PROJECT REVIEW COMMITTEE - CITY OF WILDWOOD

Agenda
Regular Meeting
May 14, 2024 10:00 AM
Commission Conference Room 124
100 N Main Street

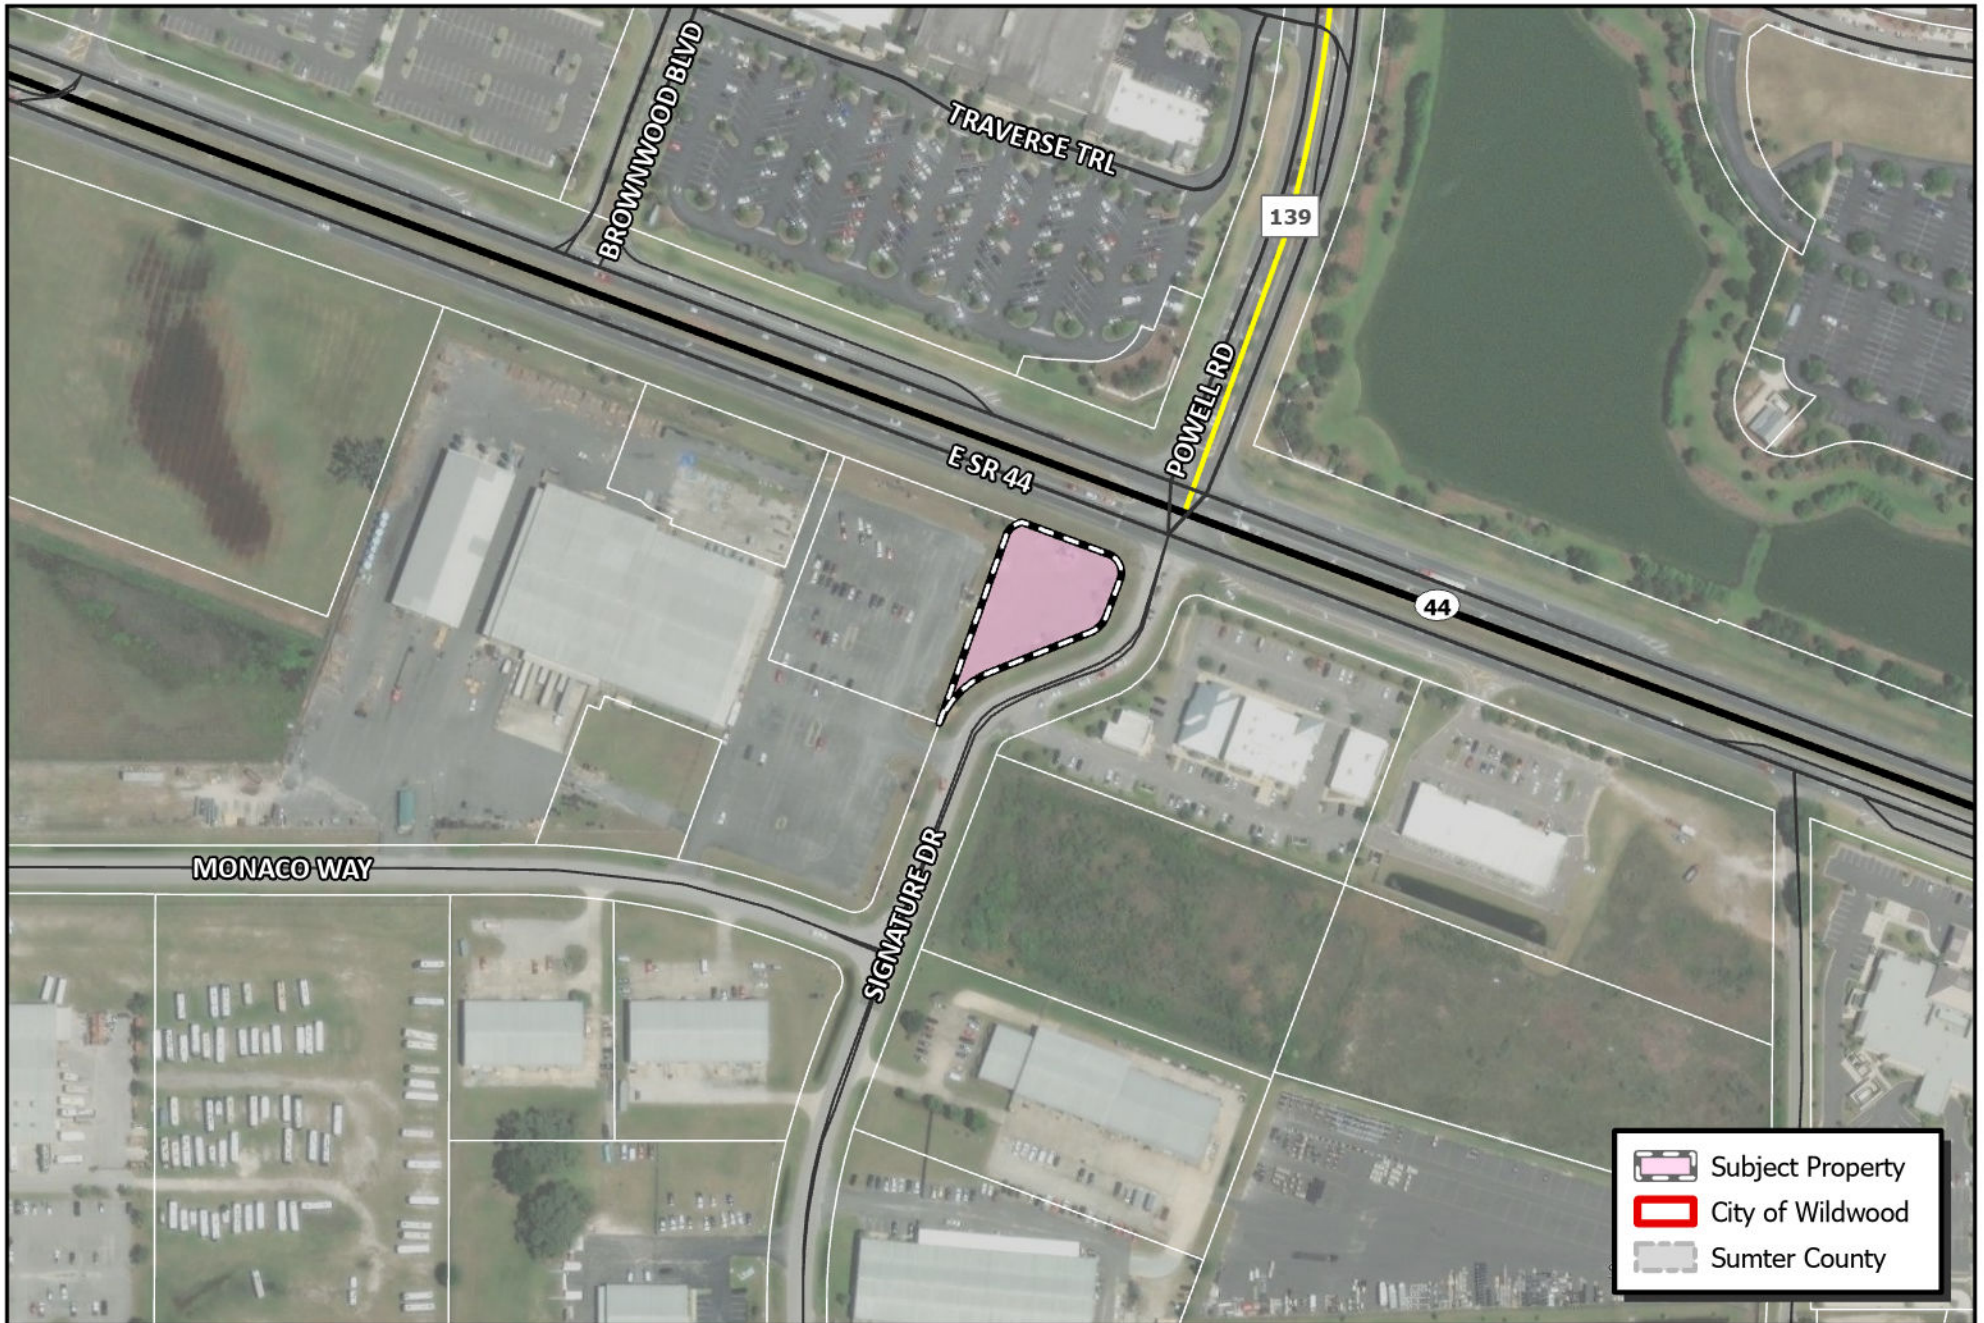
1. Sheet C-11: Relocate drop manhole MH-1 south outside of paved area.
2. Sheet C-11: Relocate 12" water main south to maintain a 10' buffer from proposed trees on sheet LP-1
